**Pacific Gas and
Electric Company®**

PG&E Letter DCL-09-086

Diablo Canyon Units 1 and 2
Docket No. 50-275, OL-DPR-80
Docket No. 50-323, OL-DPR-82

License Amendment Request 09-06, Critical Damping Value for Structural Dynamic
Qualification of the Control Rod Drive Mechanism Pressure Housings

**Structural Schematic
OEM CRDM vs. AREVA CRDM**

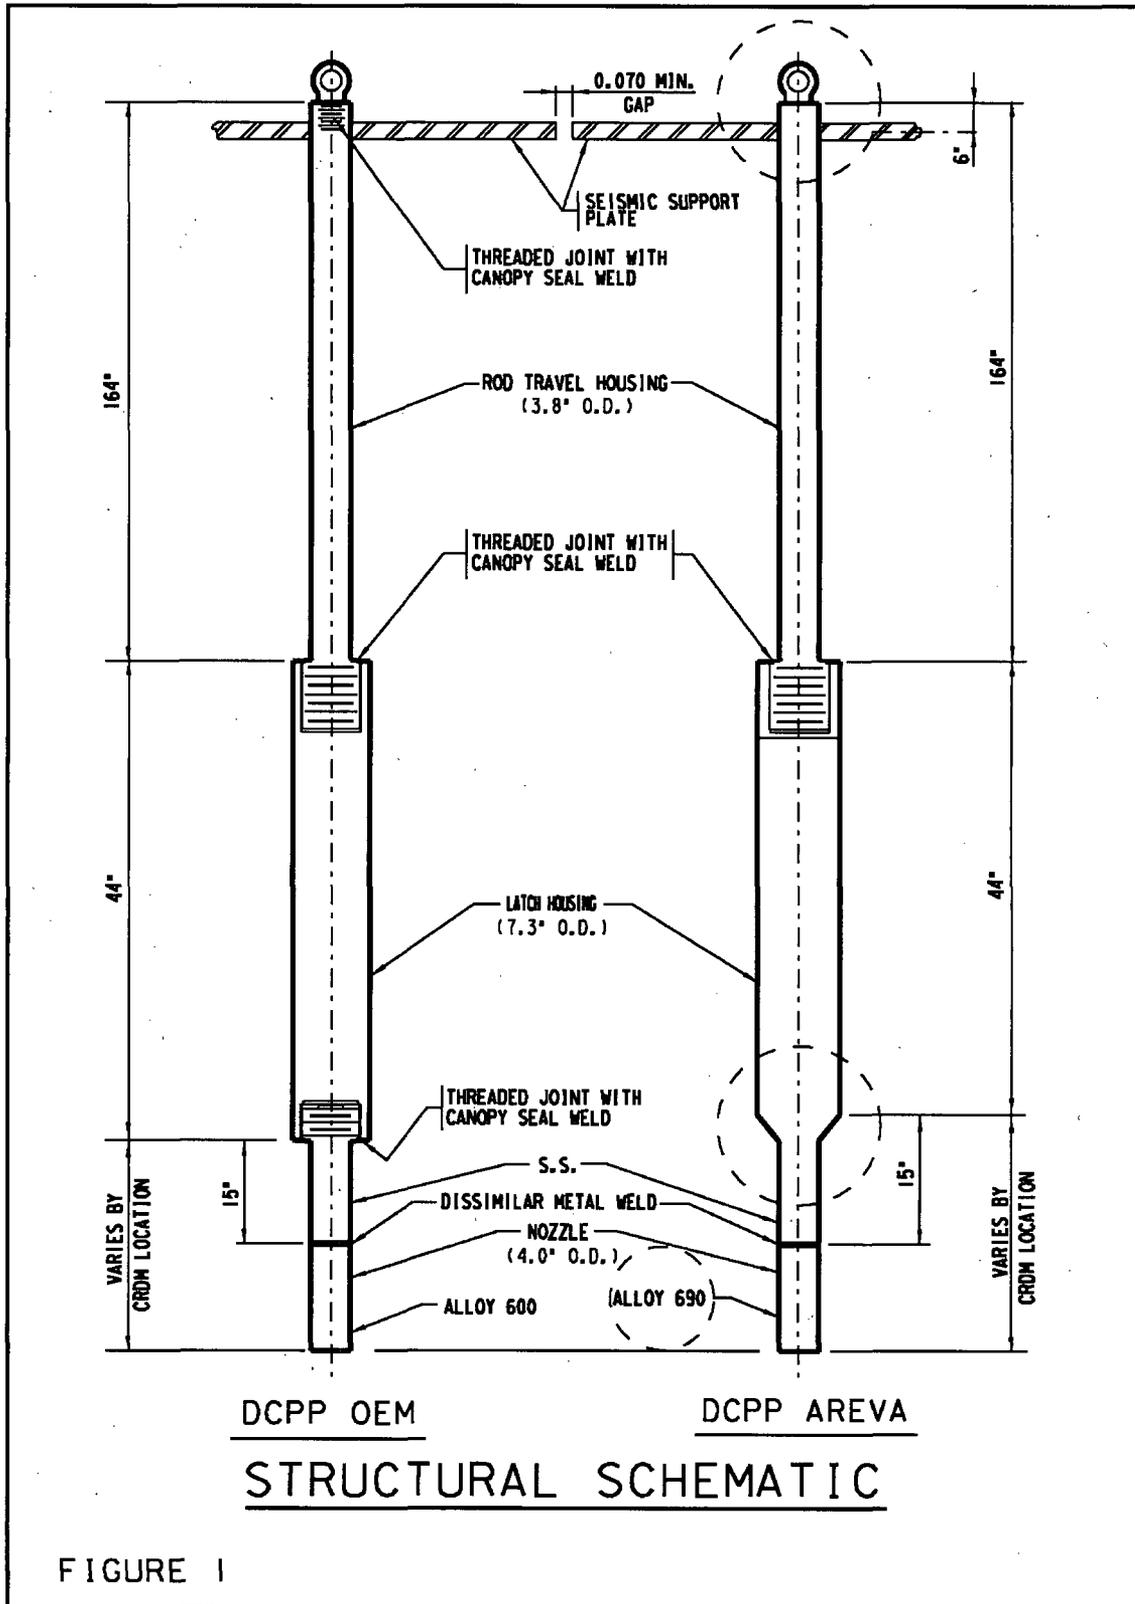
The following provides the basis of similarity between the OEM CRDM and the AREVA-supplied CRDM, as depicted in Figure 1:

1. *Gap at the seismic support plates.* The CRDM testing that supports the 5 percent damping value was based on a seismic support plate gap of 0.060-inch. The seismic support plates / seismic support structure for the replacement CRDM design provides a 0.070-inch (cold)/0.100-inch (hot) gap between the CRDM seismic support plates, consistent with the gap between the OEM CRDM seismic support plates.

2. *CRDM length.* The OEM and AREVA supplied replacement CRDMs are the same in length.
3. *Latch housing and Rod Travel Housing (RTH) materials.* The OEM and replacement CRDMs materials for the latch housing and RTH are the same type 304 stainless steel.

4. *Section properties.* The OEM and replacement CRDM geometry is essentially the same by design. Differences in tolerances are insignificant to damping.

5. *Operating parameters.* The operating parameters are the same.
6. *Appurtenances.* The existing Westinghouse Type L-106A control rod drive coil assemblies and digital rod position indicator coil stacks have been or will be installed on the replacement CRDMs

7. *Specific design differences.* The design enhancements are shown in the circled areas in Figure 1. Alloy 690 is substituted for Alloy 600 for its superior resistance to PWSCC. These materials' physical properties are equivalent and with no change in the effect on damping. Threaded joints with canopy seal welds at the top and lower positions have been eliminated in favor of one-piece construction. The OEM fine-threaded joint connections are pressure-loaded and designed to minimize or eliminate relative displacement between the joined parts; therefore, any difference in damping effects of these joint connections and the one-piece design are negligible.

Therefore, based on the similarity of the AREVA-supplied replacement CRDMs to the OEM CRDMs, 5 percent critical damping is a conservative value to use for dynamic analysis.
